FPEH Overhead reduction & Quick Decryption (16.2.2)

Document Number: S80216m-09_2745

IEEE 802.16 Working Group Letter Ballot #30b (80216-09_0073)

Discuss and approve the proposed text changes into IEEE802.16m/D4 document

FPEH in MAC PDU with AGMH

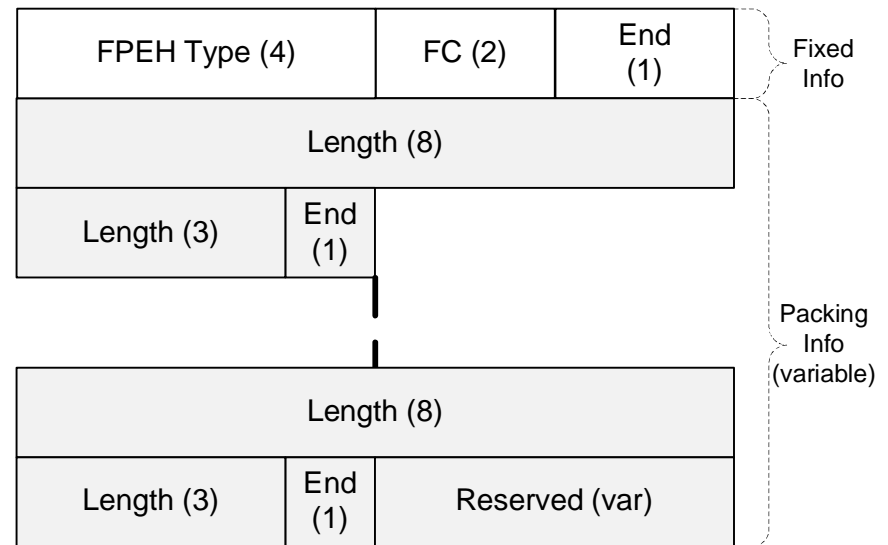
- The FPEH format in 16m (P802.16m/D3) is shown below
 - The minimum FPEH overhead in MAC PDU with AGMH can be reduced to 2 bytes by optimizing some signaling bits which are not needed in every packet

MAC PDU with MCEH

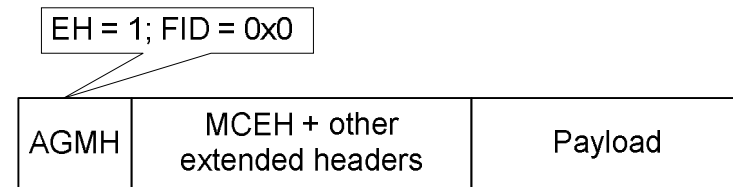
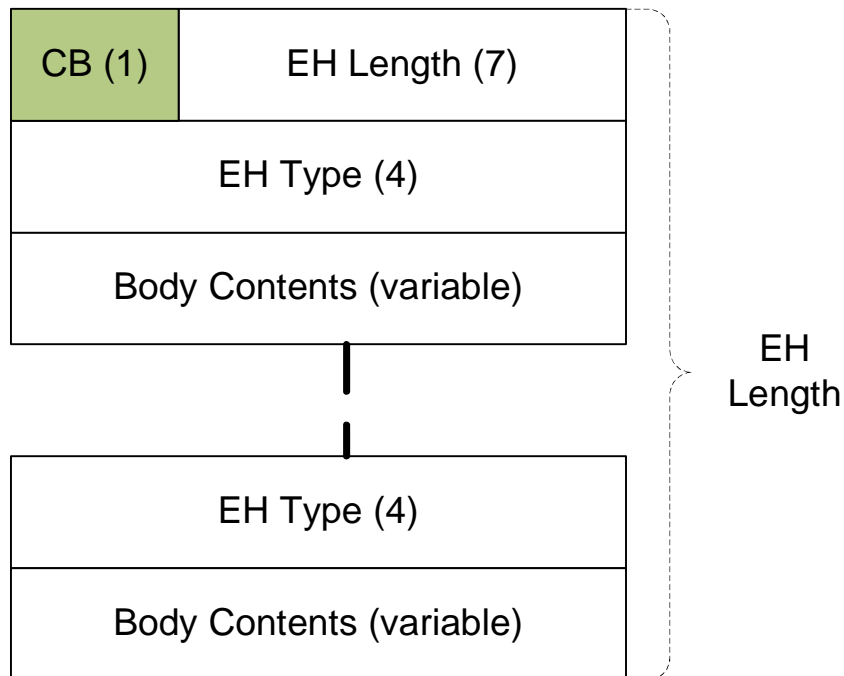
- MCEH format and MAC PDU with MCEH in D3 is shown below
 - EC bit in MCEH indicates encryption for control connection payload
 - In control connection MAC PDU, receiver has to decode MAC header and then the extended headers before it can decrypt the payload.
 - There are several EHs, which are variable in nature. This delays the processing of MAC PDU payload and hence impacts performance.
- Receiver should be able to quickly decrypt control connection payload like the transport connection payload

Modified EH Format

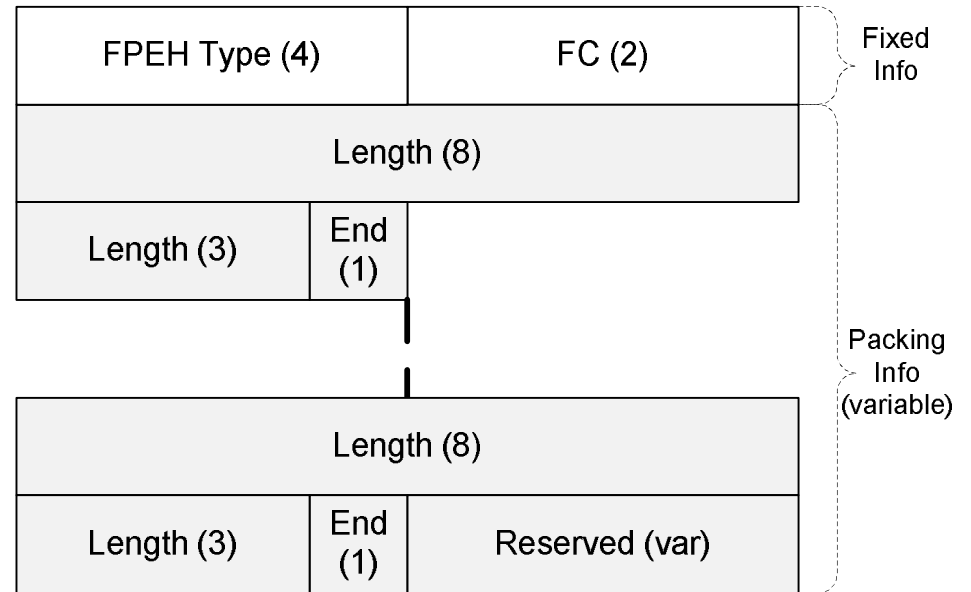
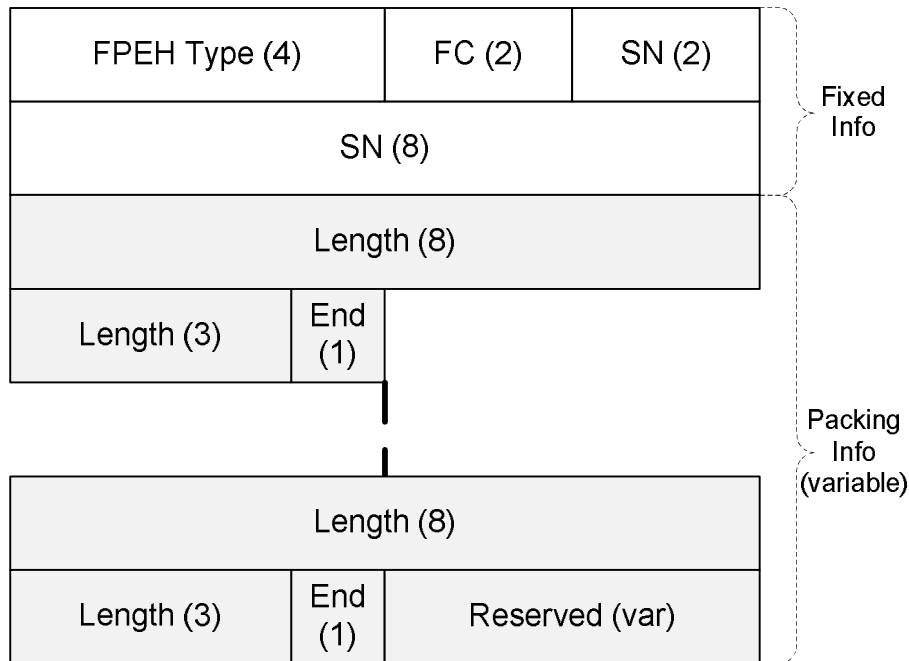
A control bit (CB) is introduced in EH format. EHLen is reduced from 8 to 7 bits

1. CB bit acts as a Packing info indicator in a transport connection MAC PDU with FPEH

2. CB bit acts as a Encryption Control Indicator in a Control Connection MAC PDU

Modified FPEH Format

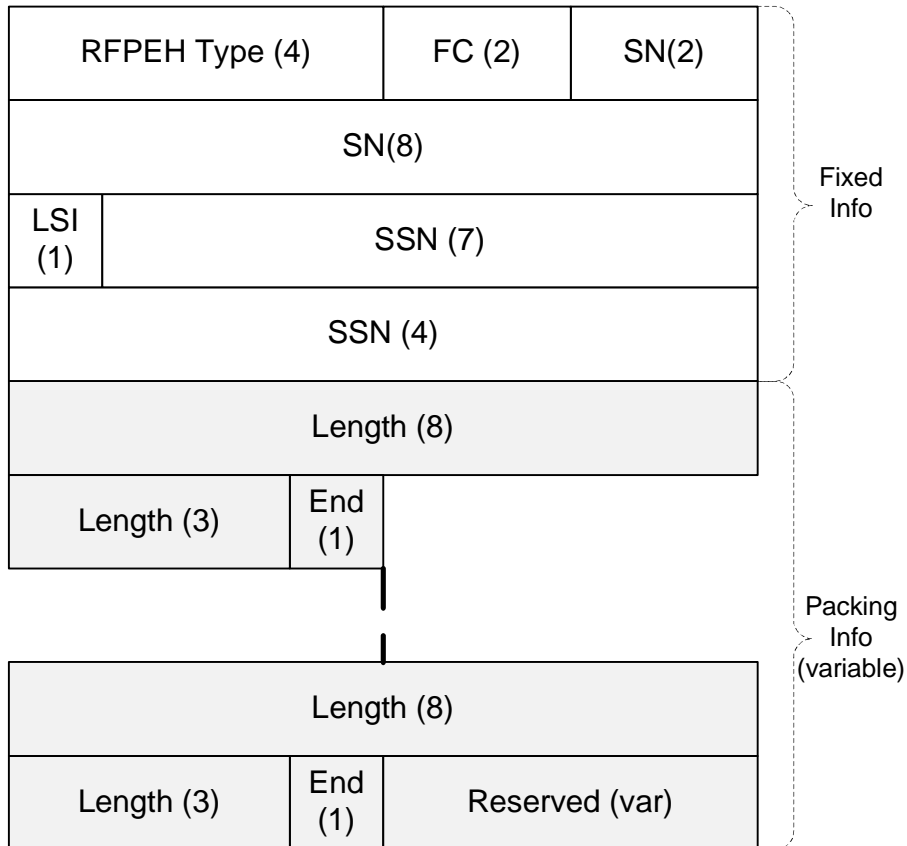
Control information (RI, AFI, AFP, SSN, LSI) are removed from FPEH. Overhead is reduced from 3 to 2 bytes.

Packing Info is present in FPEH if CB equals '1'

Modified MCEH Format

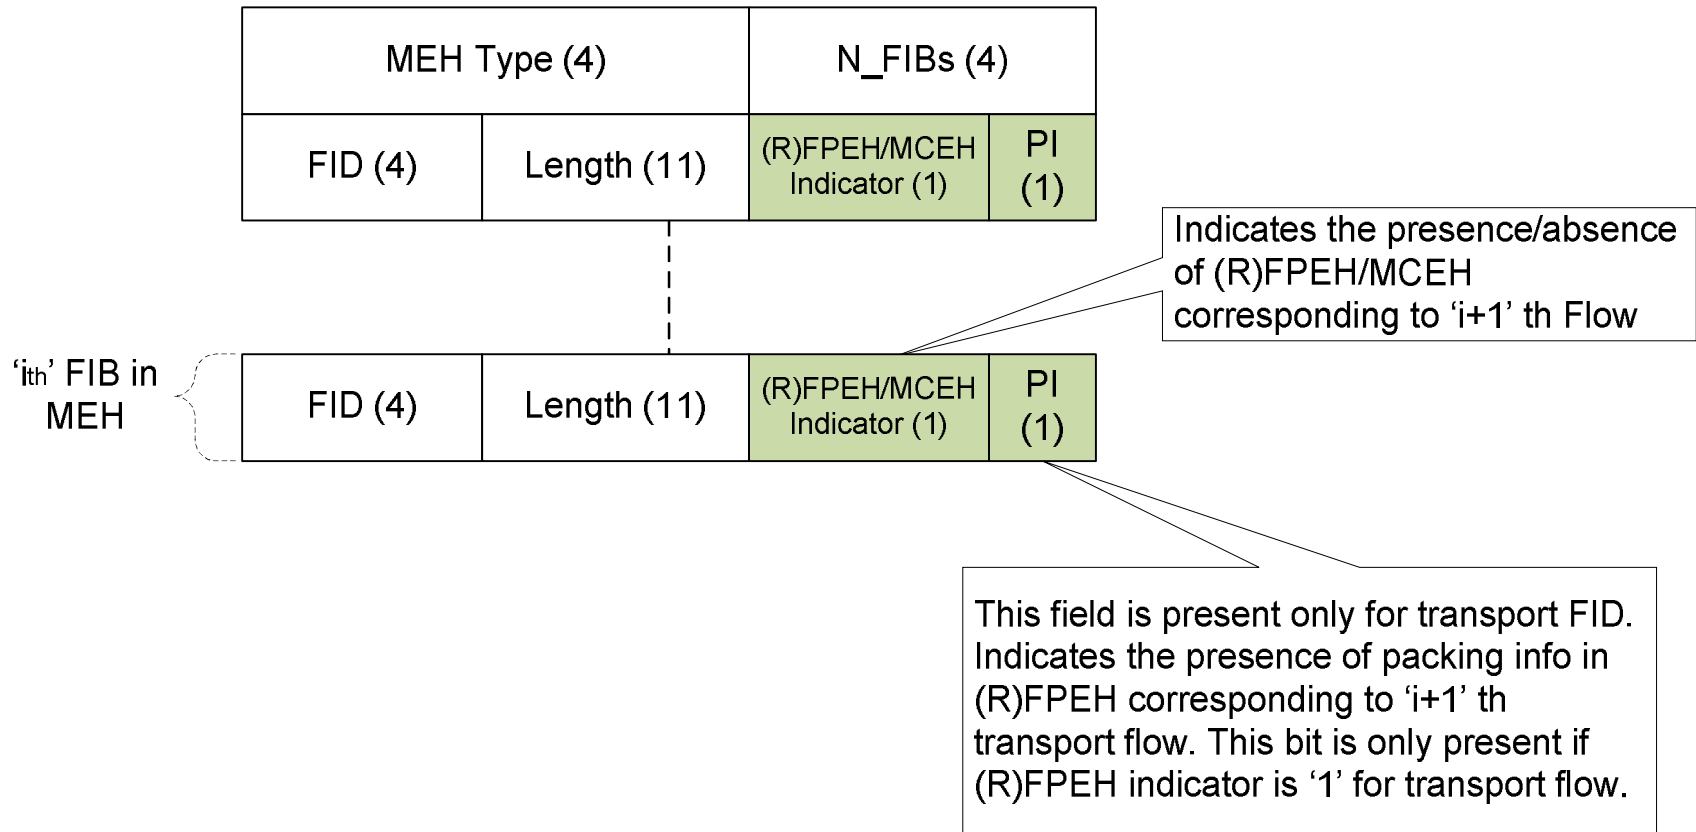
Same format as other EHs. Special handling is not required.

EC bit is removed and MCEH Type is added

Overhead is same as in D3
